STAFF REPORT: FEBURARY 10, 2021 MEETING

APPLICATION NUMBER: 21-7053

ADDRESS: 1948 CHICAGO BLVD.

SCOPE OF WORK: CONSTRUCT NEW ADDITION AT REAR, WINDOW REPLACEMENT, VARIOUS EXTERIOR MODIFICATIONS AND GENERAL MAINTENANCE

Figure 2- Mutton is 3/4"

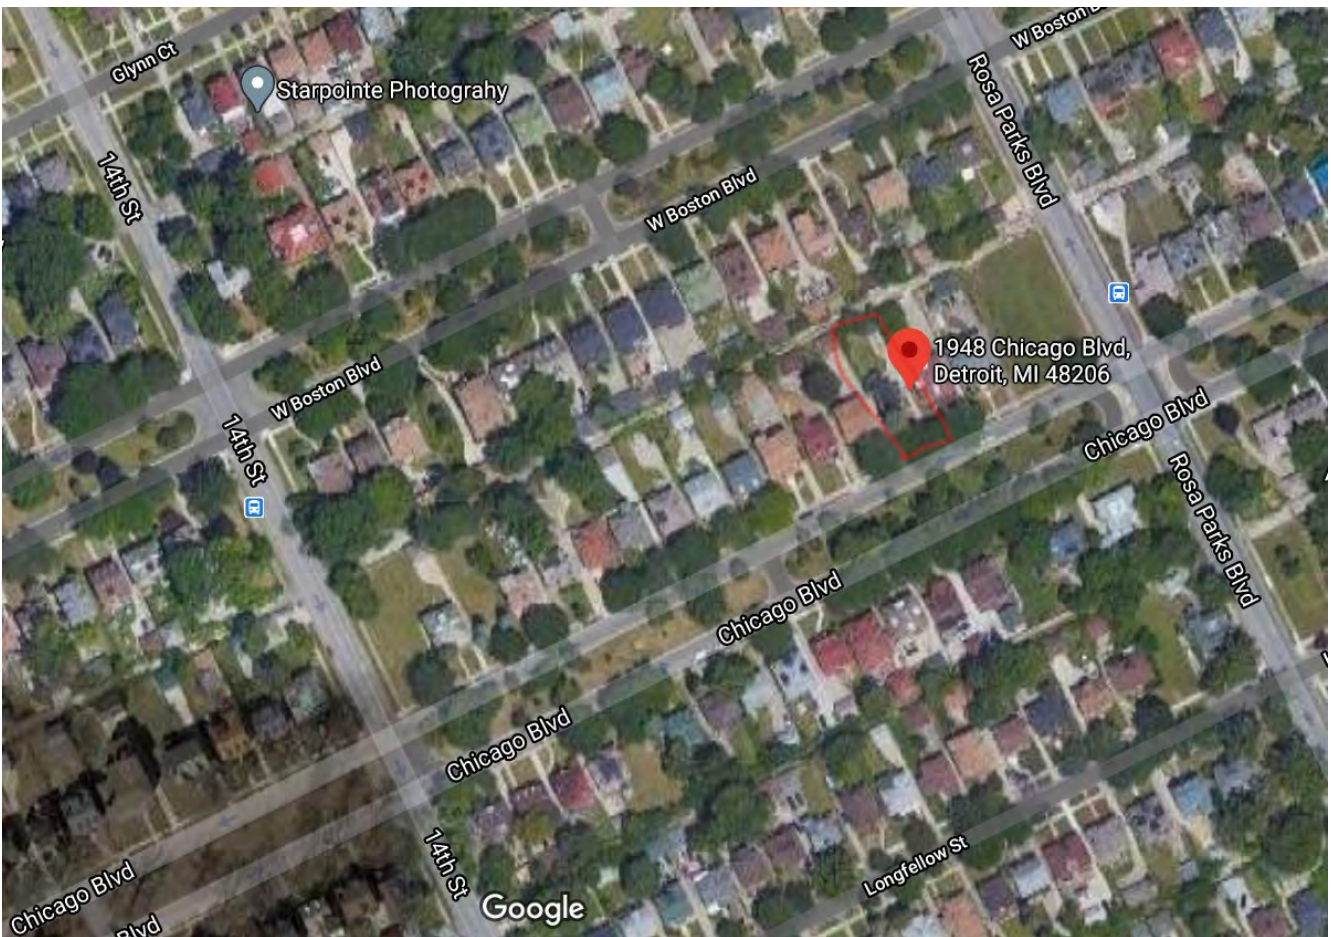
- The applicant provided staff with photo documentation of an original window from the house, that is found in a window well. These window frame dimensions measure 2-1/8" and the muntins measure 3/4".

- While it appears that the proposed windows do exhibit some traits of the original windows like casement operation and horizontal muntins, the window frames of the Andersen E-Series appear to be thicker (2-5/16" visible sash width, with simulated divided lights and 5/8" muntins) than the original windows, as steel construction allows for much thinner profiles (*National Park Service Technical Preservation Brief 13, "The Repair and Thermal Upgrading of Historic Steel Windows"*). Wood and synthetic windows are unable to match these profiles and dimensions. It is unclear if the applicant has researched any commercial or specialty window manufacturers as alternative options.

"The applicant work with staff to identify an appropriate aluminum or steel window product, well-suited for single family residential use and with reasonable economic and technical feasibility, with such feasibility considered as part of a phased approach to window replacement. Should staff and the applicant be unsuccessful in identifying a product by the deadline for the March meeting, the application may be returned to the Commission at that meeting for reconsideration, accompanied by a staff report outlining the research and investigation results."
